ALTON SPRING HILL REZONING PLAN  
2181 HENNAWAY  
WALTERS  
LOCATED IN  
REVISION

**PETITION NO:** Z-41  
**HEARING DATE (PC):** 11-01-2011

**PROPOSED USE:** Residential Condominiums

**ZONING COMMENTS:**

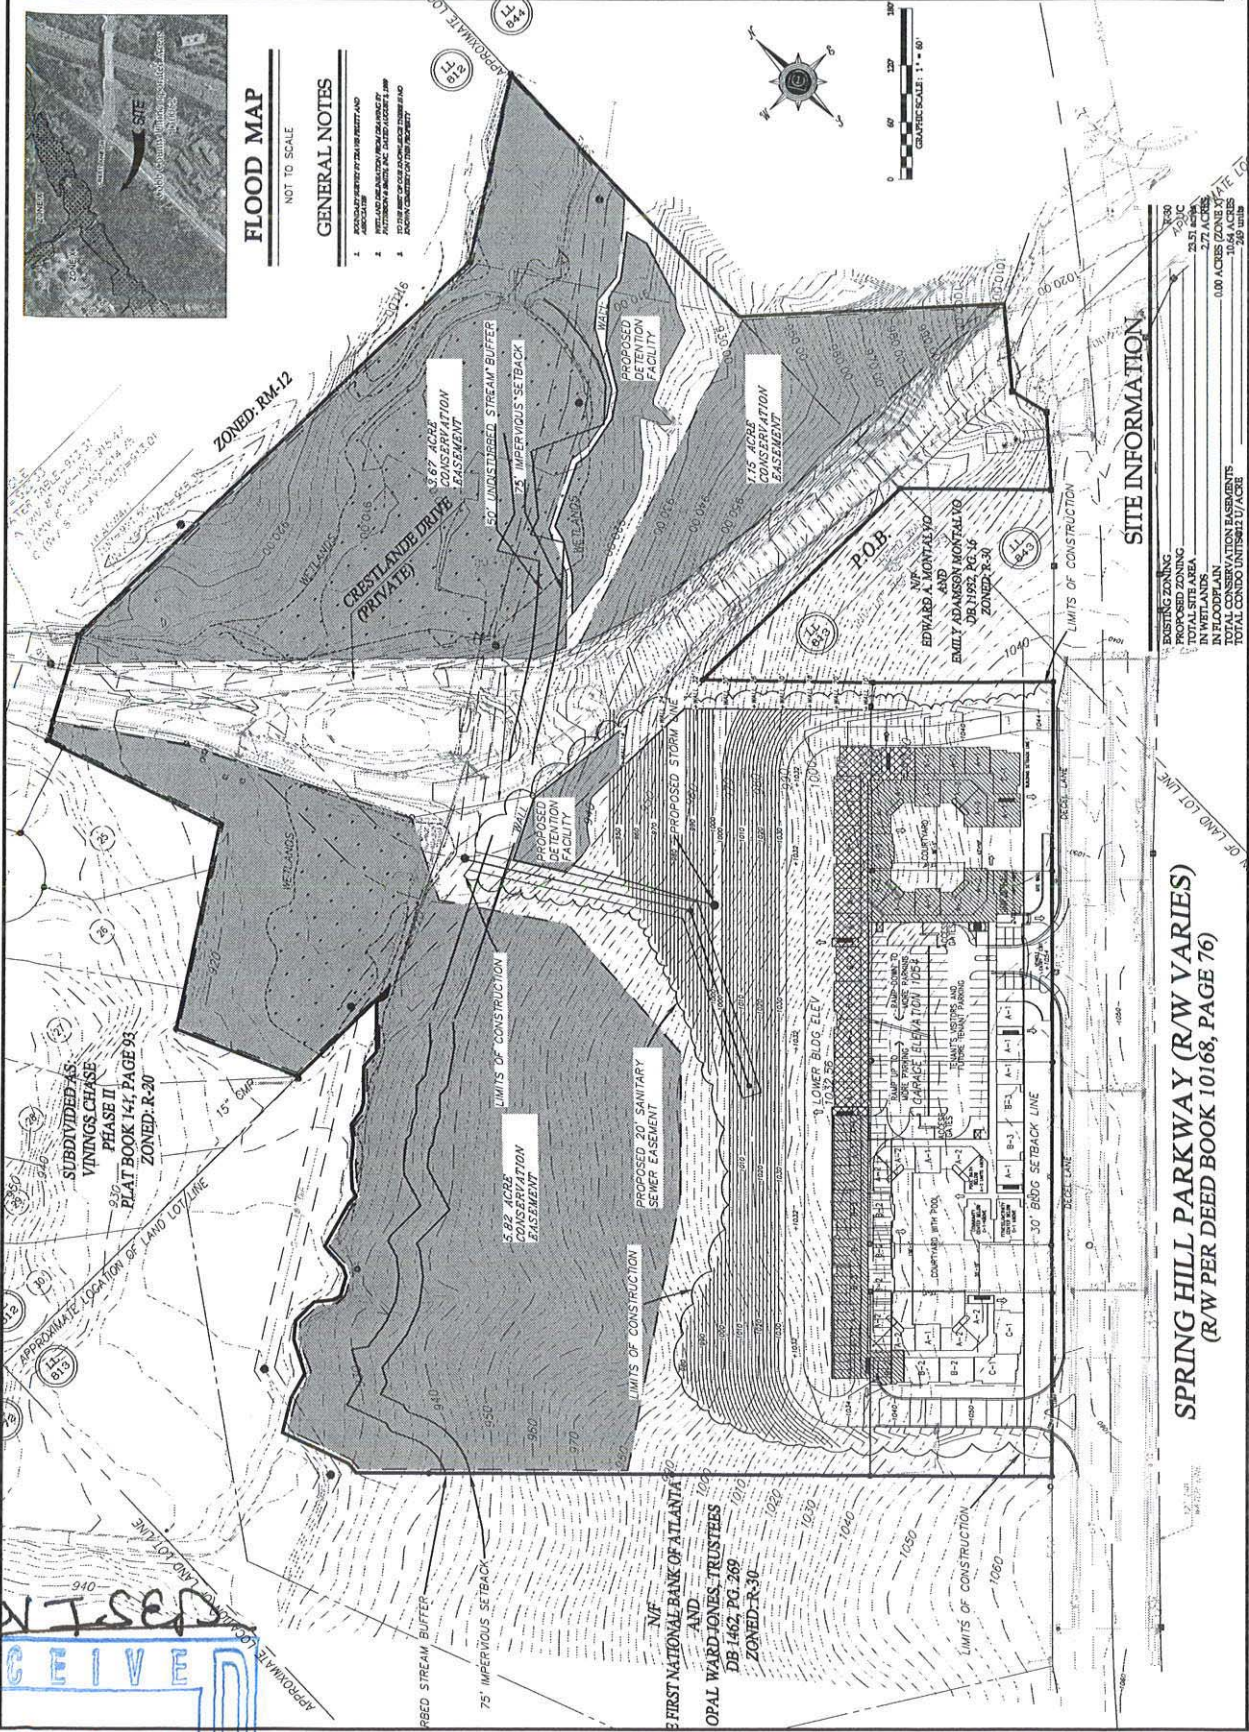
**DRAINAGE COMMENTS**

FLOOD HAZARD:  YES  NO  POSSIBLY, NOT VERIFIED

DRAINAGE BASIN: Chattahoochee River FLOOD HAZARD INFO: Zone A

- FEMA Designated 100 year Floodplain Flood.
- Flood Damage Prevention Ordinance DESIGNATED FLOOD HAZARD.
- Project subject to the Cobb County Flood Damage Prevention Ordinance Requirements.
- Dam Breach zone from (upstream) (onsite) lake – need to keep residential buildings out of hazard.

Location: identified on plan

- Metropolitan River Protection Area (within 2000’ of Chattahoochee River) ARC (review 35’ undisturbed buffer each side of waterway).
- Chattahoochee River Corridor Tributary Area – County review (\_\_\_\_\_ undisturbed buffer each side).
- Georgia Erosion-Sediment Control Law and County Ordinance – **County Review**/State Review.
- Georgia DNR Variance may be required to work in 25 foot streambank buffers.
- County Buffer Ordinance: **50’, 75’, 100’ or 200’** each side of creek channel.

- Provide comprehensive hydrology/stormwater controls to include development of out parcels.
- Submit all proposed site improvements to Plan Review.
- Any **spring activity** uncovered must be addressed by a qualified geotechnical engineer (PE).
- Structural fill must be placed under the direction of a qualified registered Georgia geotechnical engineer (PE).
- Existing facility.
- Project must comply with the Water Quality requirements of the CWA-NPDES-NPS Permit and County Water Quality Ordinance.
- Water Quality/Quantity contributions of the existing lake/pond on site must be continued as baseline conditions into proposed project.
- Calculate and provide % impervious of project site.
- Revisit design; reduce pavement area to reduce runoff and pollution.

- No Stormwater controls shown \_\_\_\_\_
- Copy of survey is not current – Additional comments may be forthcoming when current site conditions are exposed.
- No site improvements showing on exhibit.

1. A significant portion of this site is encumbered by floodplain, wetlands and steep slopes. The proposed development will be located on slopes of 25 to 35% and fill heights of 10 to 40 feet. Due to the proximity of the stream, elevated erosion and sediment control measures will be required. At a minimum, a mulch berm should be placed along the lower clearing limit boundary to protect the stream buffer and proposed conservation easement area. The limits of disturbance could be significantly reduced with the use of retaining walls.
2. The proposed detention ponds must be located outside the 100-year floodplain and wetlands.

Recommend one full access driveway, one right-in/ right-out driveway and removing the northeastern full access driveway.

Recommend installing a deceleration lane for the full access driveway.

Recommend sidewalk along frontage.
